Re: Inspection Summary Letter
Huntington First Brethren Church
PWSID# IN2350008
Huntington, Huntington County

Type of Inspection: Sanitary Survey Inspection
Primary Inspector: Darek Petro: dpetro@idem.in.gov or 317-617-9350

Public Water System Sanitary Survey Report

PWS ID: IN2350008 PWS Name: HUNTINGTON FIRST BRETHREN CHURCH

1 A **Minor** deficiency was identified regarding: **Top of the well is not protected**

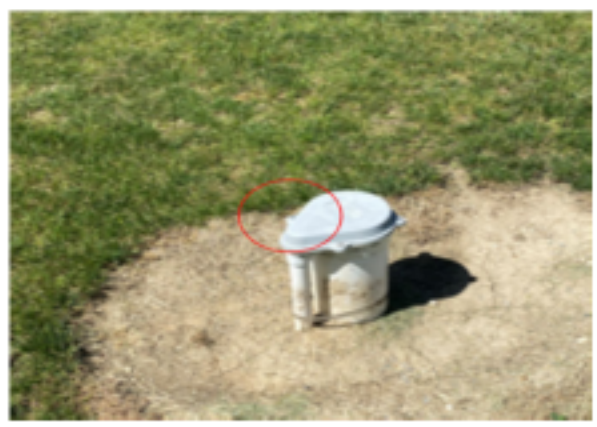
The inspector noted: “Deficiency - 327 IAC 8-2-8.2{e}{1}{G}{iii) The system shall replace missing fastener nut on well cap.”

2 A **Minor** deficiency was identified regarding: **Inadequate source water sample tap**

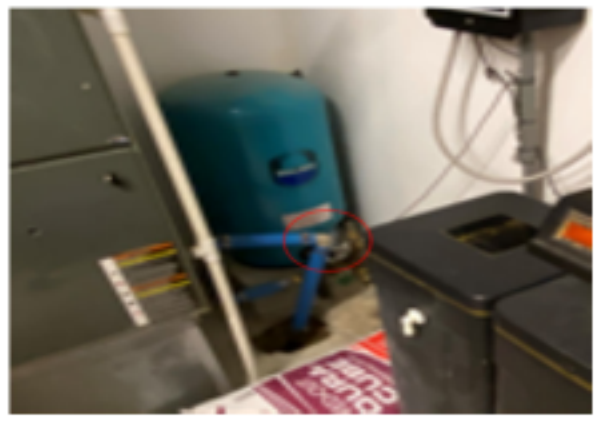
The inspector noted: “Deficiency - 327 IAC 8-2.3-2{b){6) The system is to install a smooth bore sample tap at a location prior to any storage or treatment. The tap is to be located at least eighteen (18) inches from the floor, in a location with relatively constant flow and readily accessible. The tap is to be smooth bore with no interior or exterior threads.”

3 A **Minor** deficiency was identified regarding: **Chemical storage is not adequate**

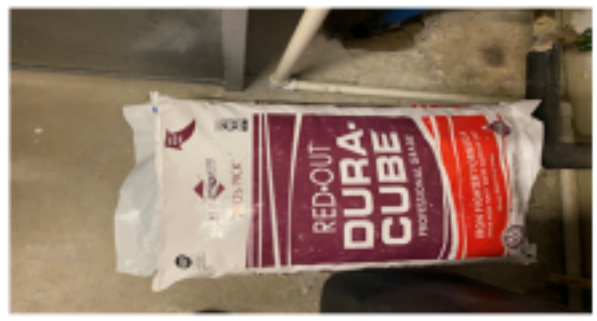
The inspector noted: "10 States Standards 5.1.9, 5.1.10, & 5.1.11 The system shall store salt on a pallet, shelf, or other location off the floor."

4 A **Minor** deficiency was identified regarding: **Cross connection(s) in the treatment process**

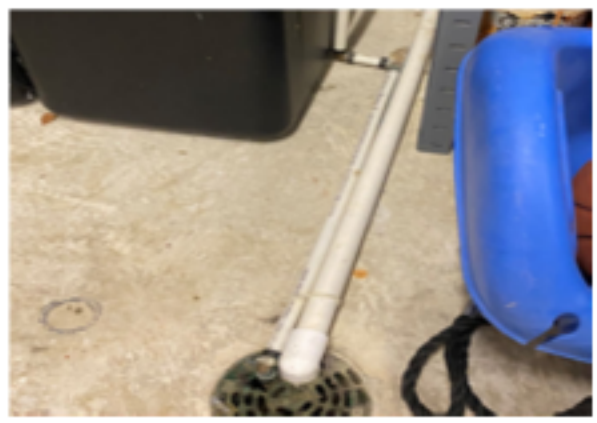
The inspector noted: "Deficiency - 327 IAC 8-10 System is to provide an air gap separation on the water softener discharge drain tube to the drain. A minimum of one (1) inch is to be provided."

SO04 Top of the well is not protected

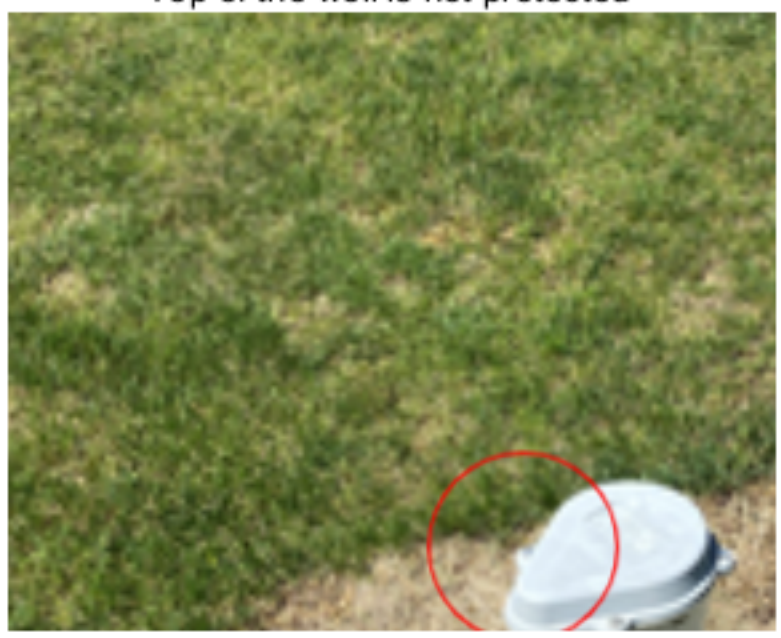
Deficiency - 327 IAC 8-2-8.2{e){1){G){iii)
The system shall replace missing fastener nut on well cap.

SO17 Inadequate source water sample tap

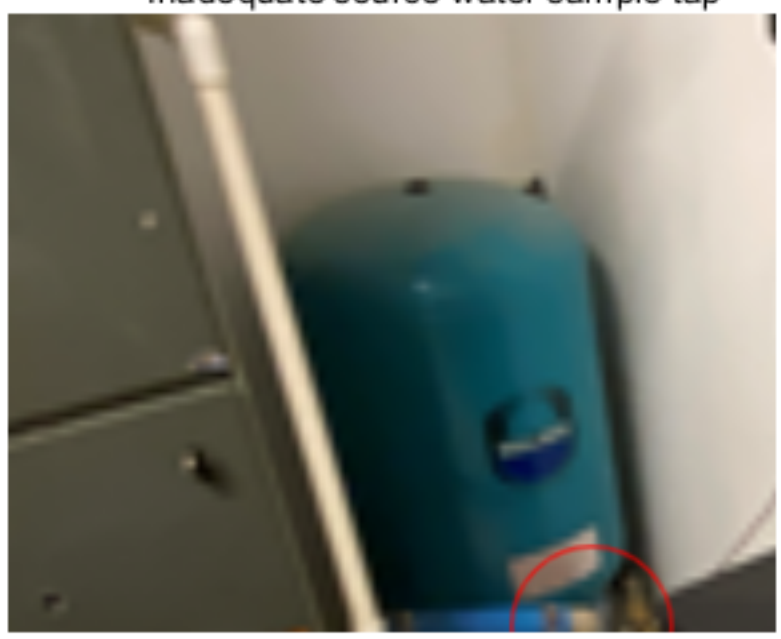
Deficiency - 327 IAC 8-2.3-2{b){6)
The system is to install a smooth bore sample tap at a location prior to any storage or treatment. The tap is to be located at least eighteen (18) inches from the floor, in a location with relatively constant flow and readily accessible. The tap is to be smooth bore with no interior or exterior threads.

1 **Is chemical storage adequate?**

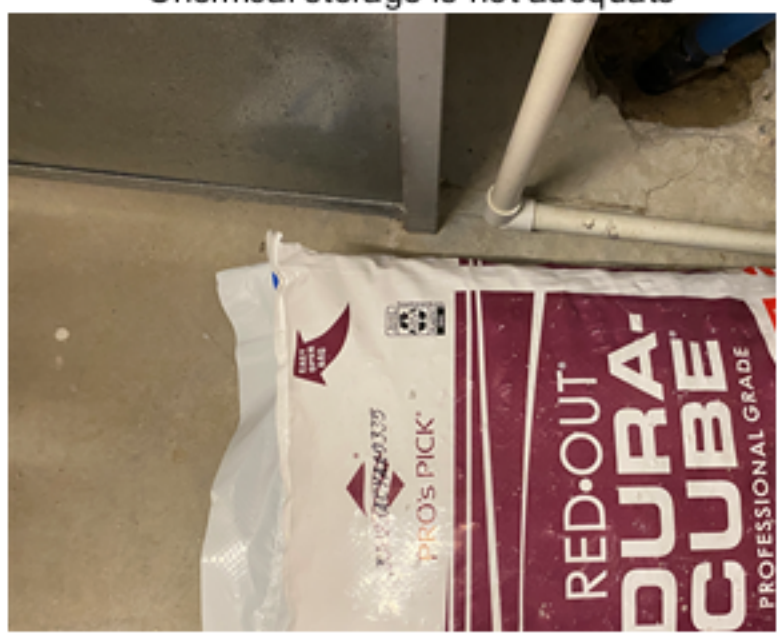
10 States Standards 5.1.9, 5.1.10, & 5.1.11
The system shall store salt on a pallet, shelf, or other location off the floor.
TR01 Chemical storage is not adequate

TR11 Cross connection(s) in the treatment process

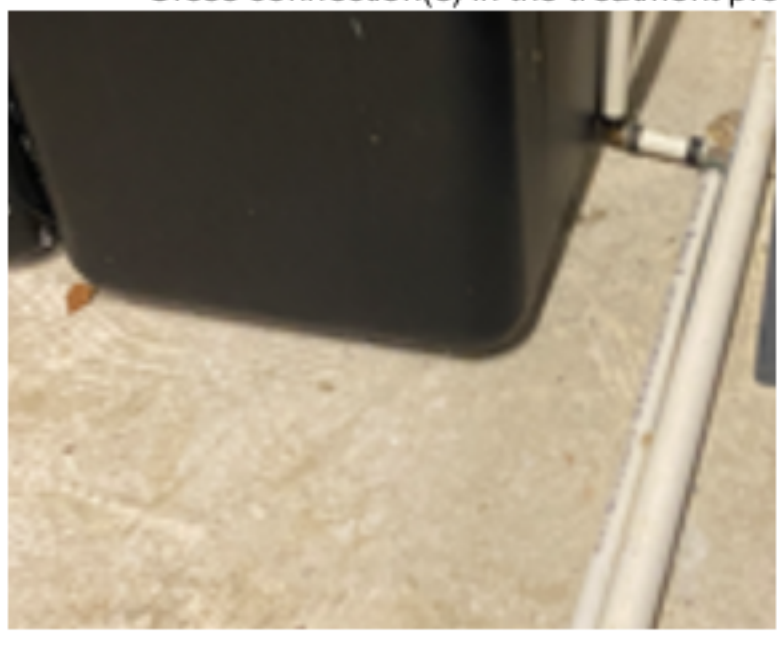
Deficiency - 327 IAC 8-10
System is to provide an air gap separation on the water softener discharge drain tube to the drain. A minimum of one (1) inch is to be provided.
